SUBMISSION (2443470-AA-DA 3104 B)

1. Preamble

- 1.1 The Manly Rugby Football Club (MRFC) has been a tenant at Manly Oval for over 100 years. The Club plays in the premier rugby union division known as the “Shute Shield” and has provided over the 100 years of its tenancy at the Manly Oval a unique profile within the district.

" DIAGRAM 1 "

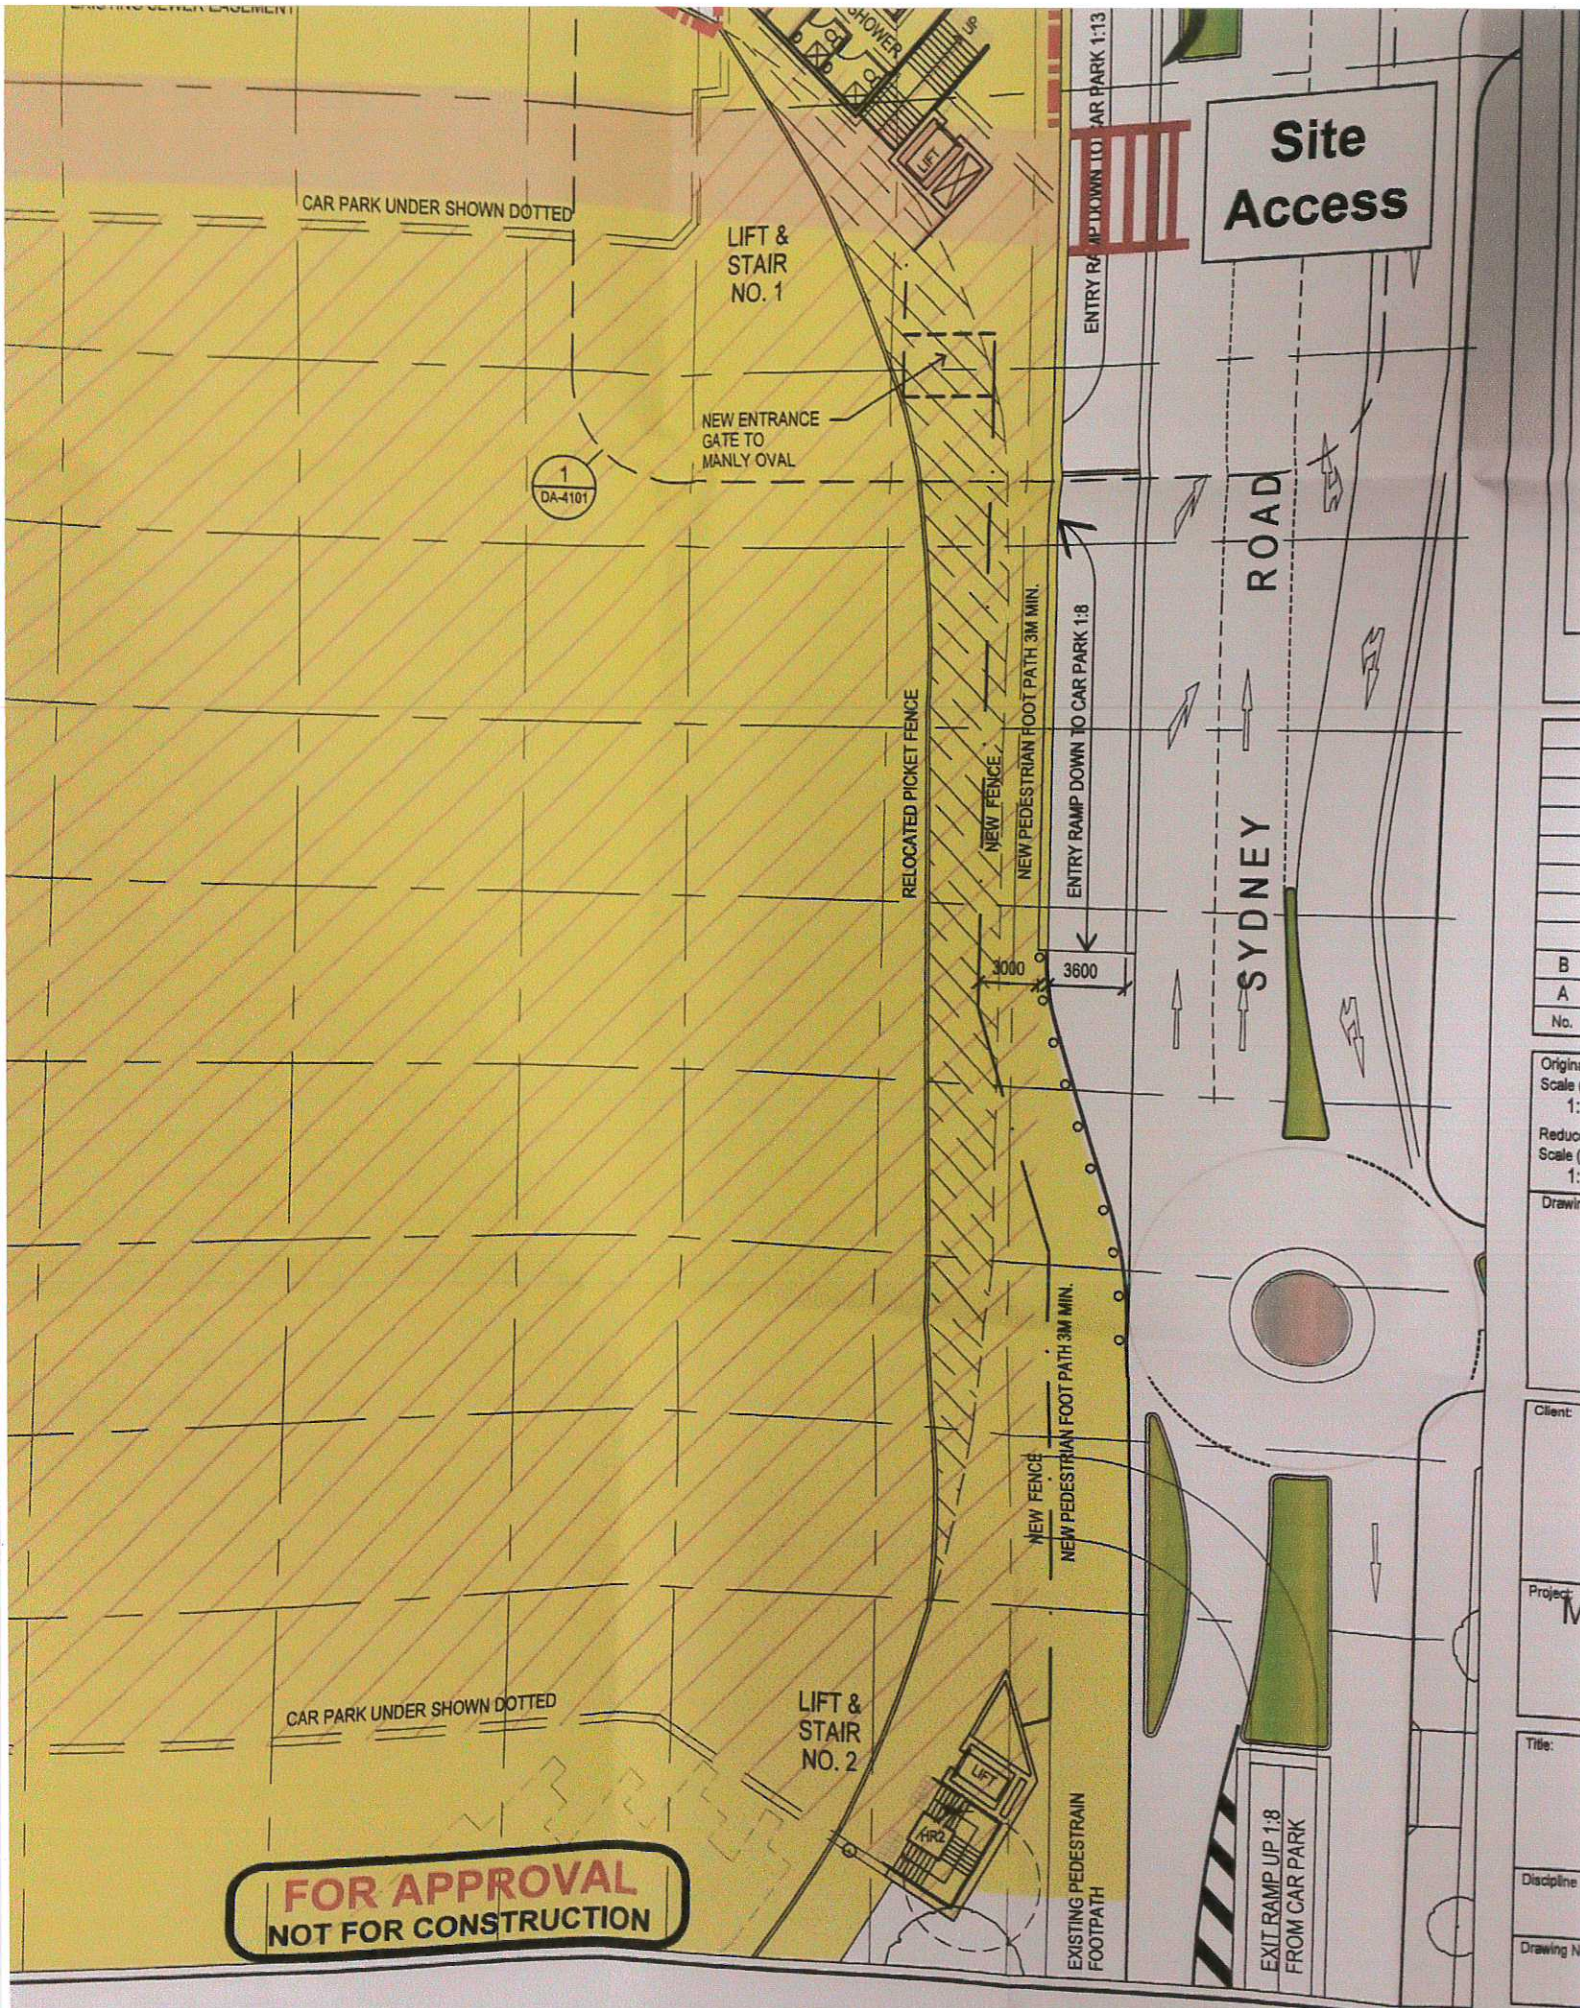
3.1 The DA plans to reduce the size of the ground at the Sydney Road boundary **(Diagram 1)**. The plans show:

- 3.1.3 The boundary of the current picket fence will be moved by around 3.5 meters onto the ground as marked in red to make way for an internal entrance to the ground (**Diagram 4**).

- 3.2 The ultimate boundary of the picket fence will be located on the current dead ball line, which will force a change to the dead ball line reducing the size of the ground and creating a potential safety risk unless the current distance between the dead ball and the picket fence (currently at 3 meters in the middle and less than 1 meter at the edges)) is retained.

- 3.3 A reduction by 3.5 meters will have the effect of reducing the size of the Oval and may potentially mean that the ground is unable to be used by the MRFC as a first division ground.

6.1 The DA is conditional upon the consent authority being satisfied that the proposed changes to the dimensions of the boundaries of the ground do not prevent the MRFC from playing on the ground because of those changed dimensions or such changes are neither unsafe or do not comply with the relevant rules required as such a first division rugby ground.

"Diagram 2"

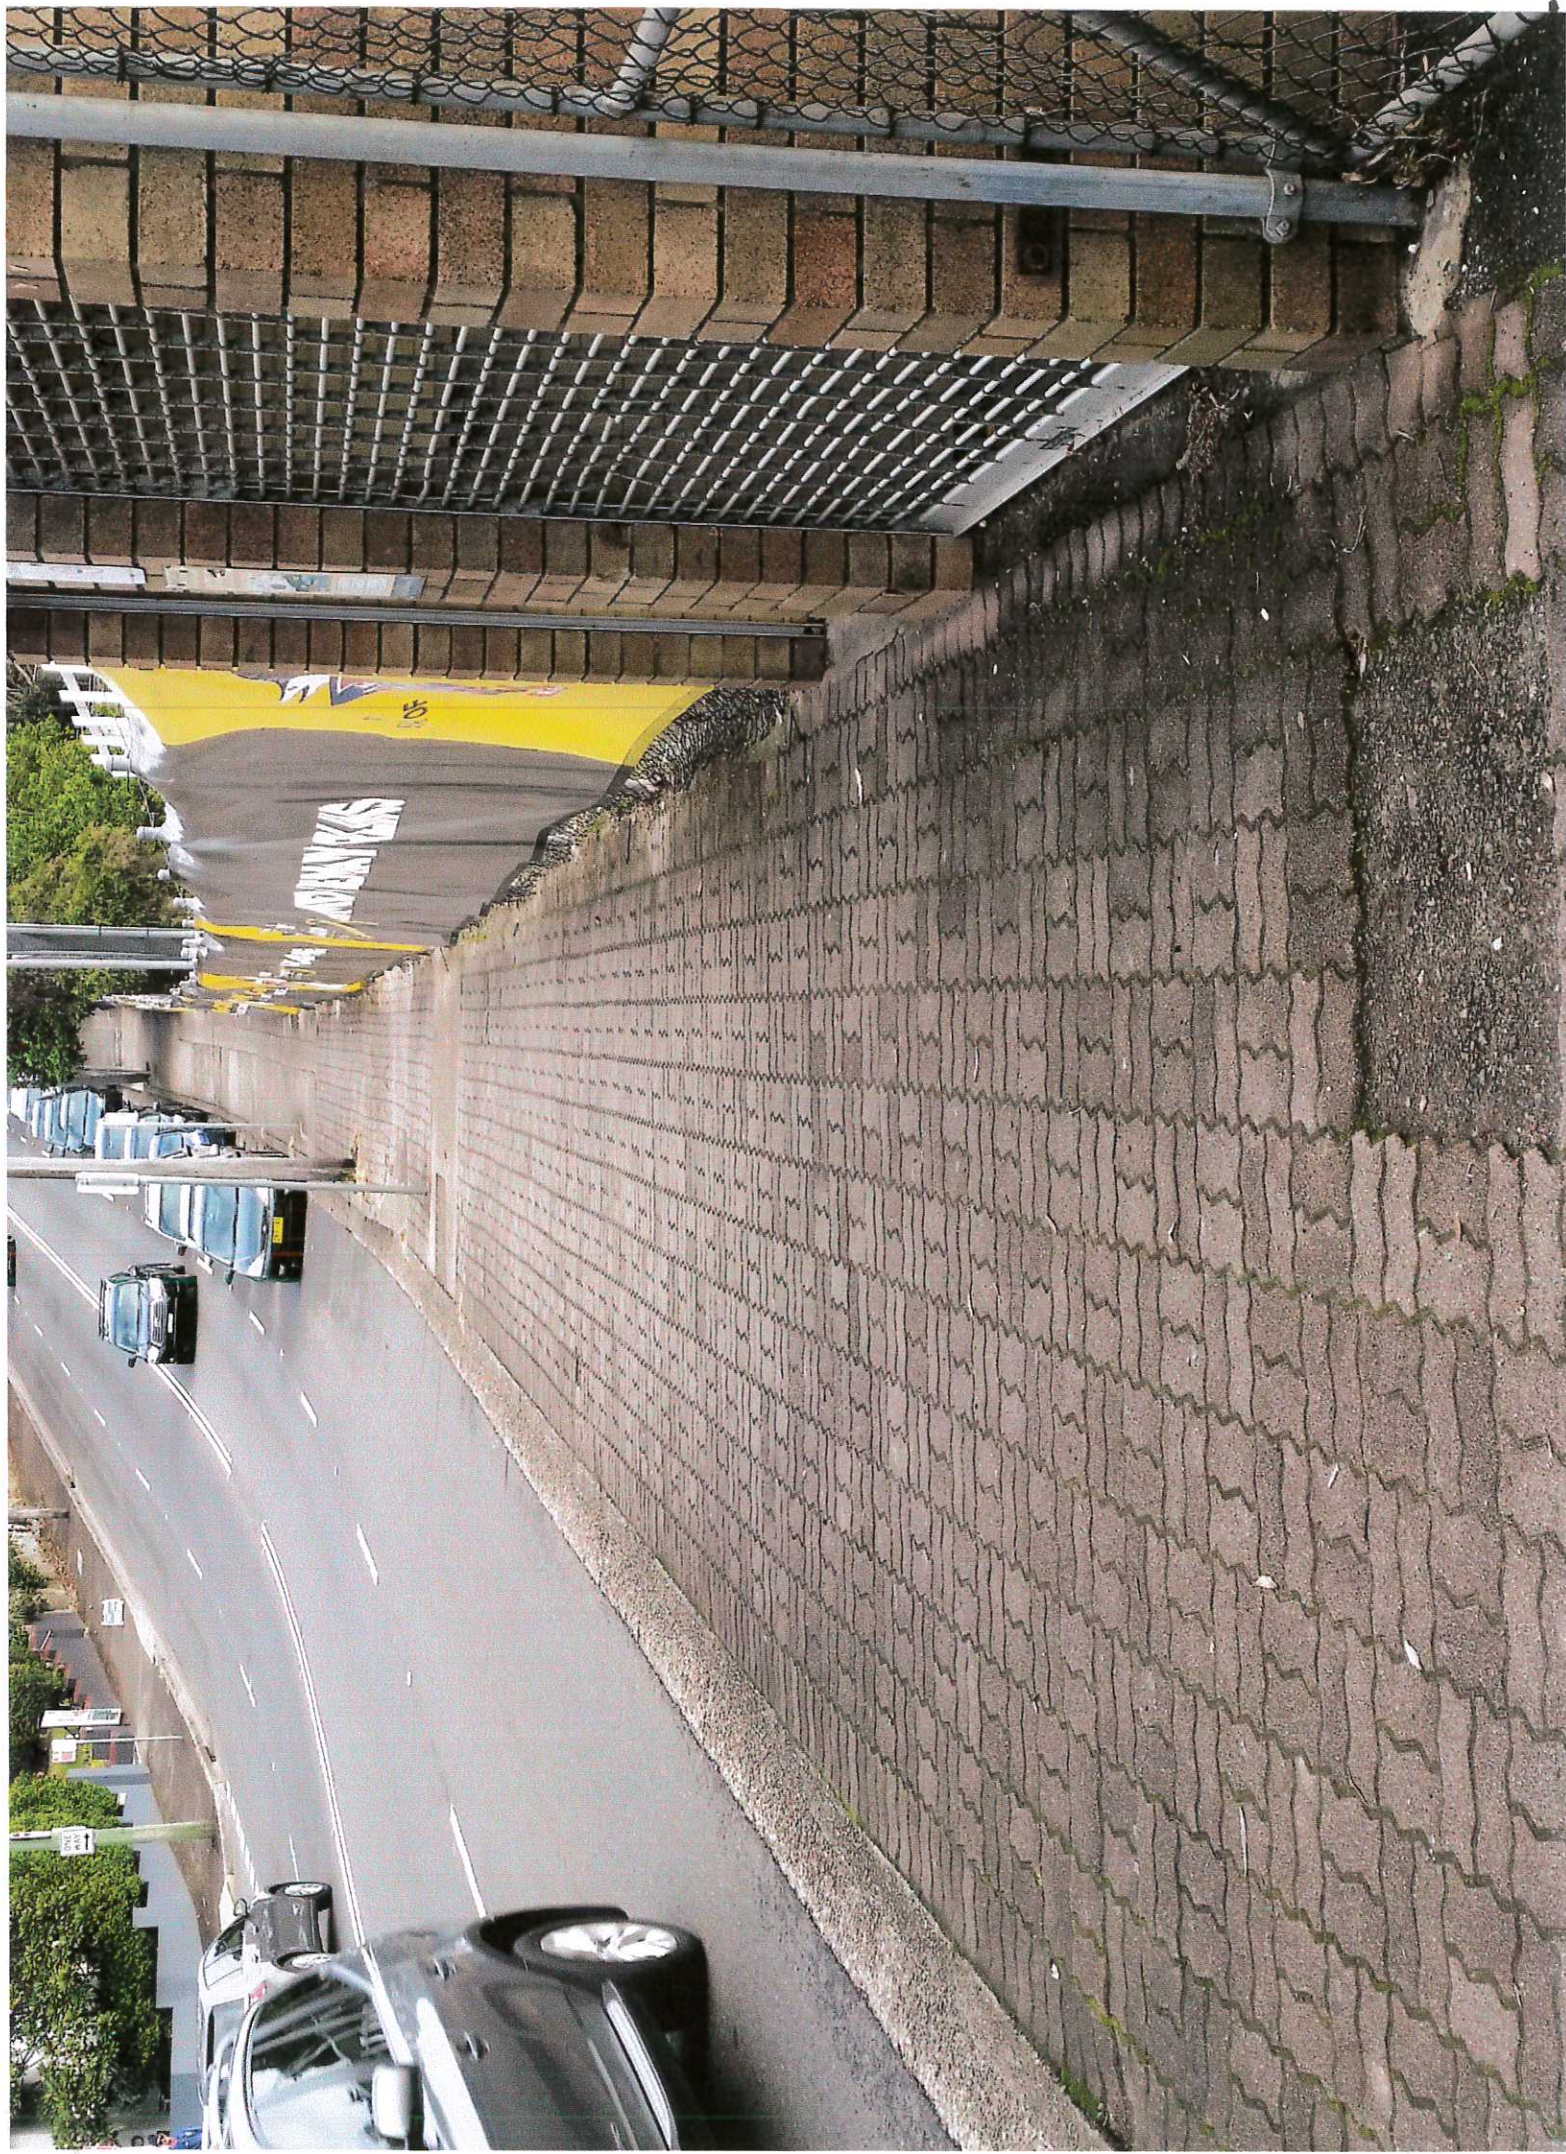
3.1.1 The external walkway **(Diagram 2)** will be removed and replaced as the entrance to the carpark.

3.1.2 The internal walkway **(Diagram 3)** will become the external walkway for members of the public.
